Objections to the Weigall Project

Address: Paddington, NSW 2021
Application: Weigall Sports Complex, Sydney Grammar School

Application Number: SSD-10421

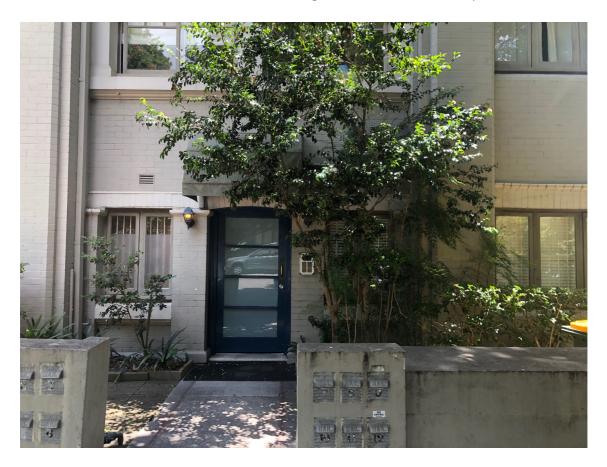
Environmental consciousness encourages the use of passive cooling methods in construction and this is an area where apartments in the block have been well served.

Strata laws for the block prevent the installation of air conditioning units, and portable units are not feasible due to the small floor areas of the units (about 49 sq m).

This development will reduce the efficacy of these nature air flows and we will be less able to cool the apartments in Summer.

In winter, direct sunlight reduces energy bills and with this development we will no longer be able to benefit from this passive heating.
